Final Drainage Report

# Meadowbrook Park El Paso County, Colorado

PCD File No.: PUDSP208  
SF-21-025

Prepared: March 18th, 2021  
Revision 1: June 2, 2021  
Revision 2: July 14, 2021  
Revision 3: September 30, 2021

## Routed Hydrograph Results

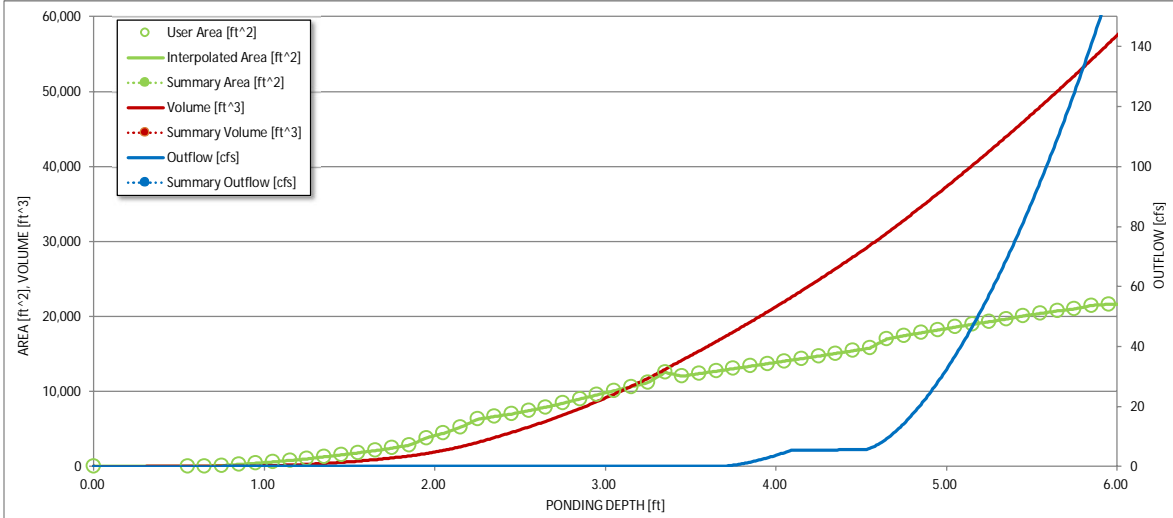
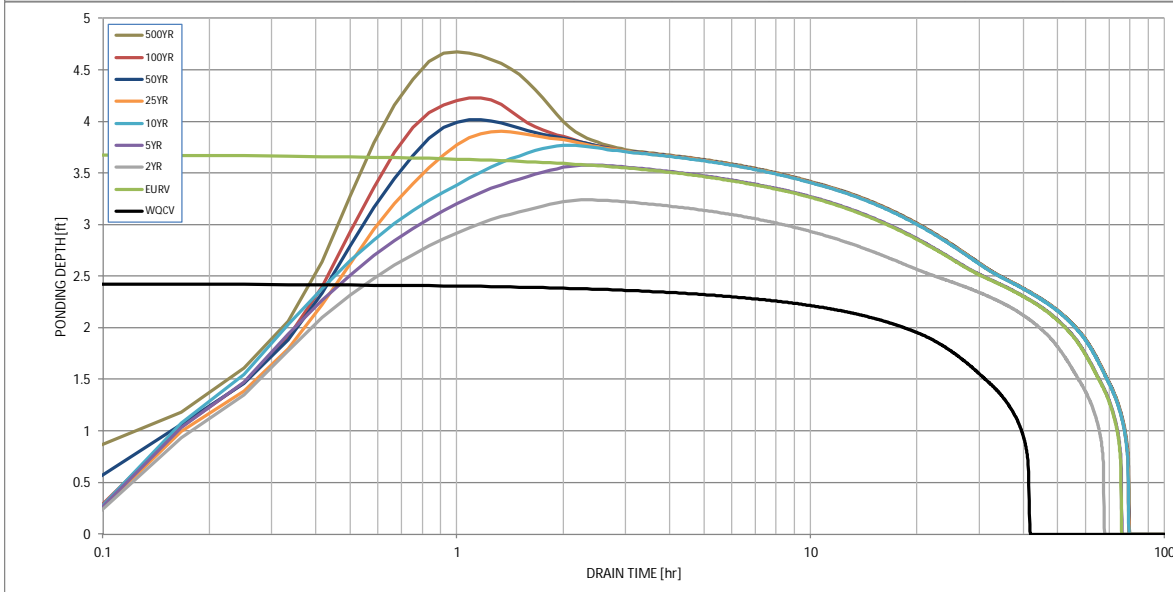
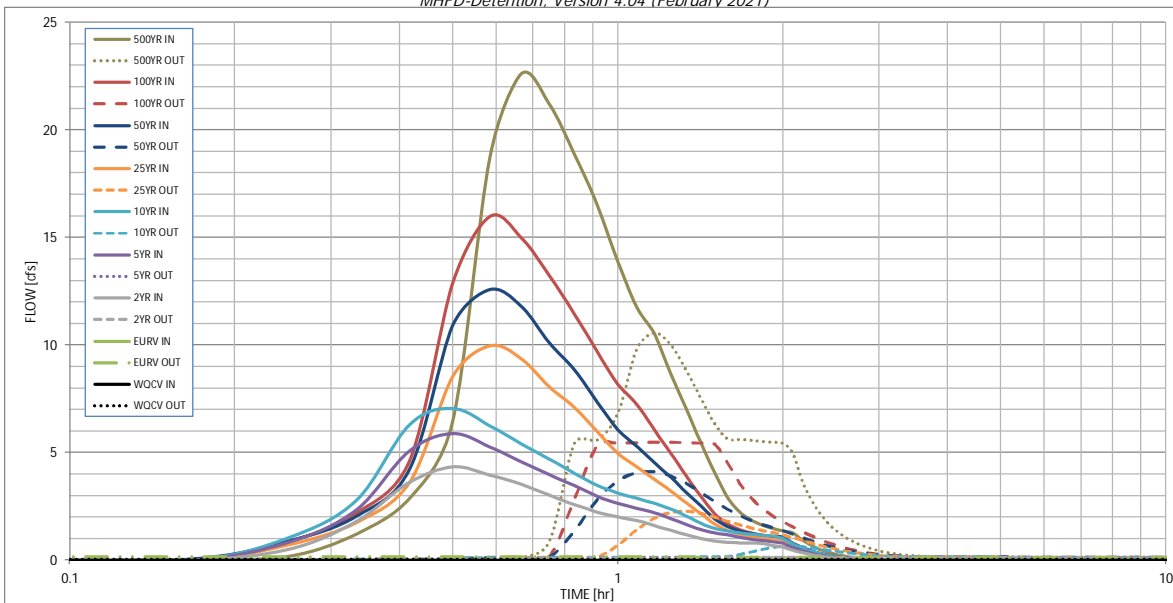
review 1 comment: Please adjust so that the released flow is equal to or less than pre-development  
Review 2: Unresolved.
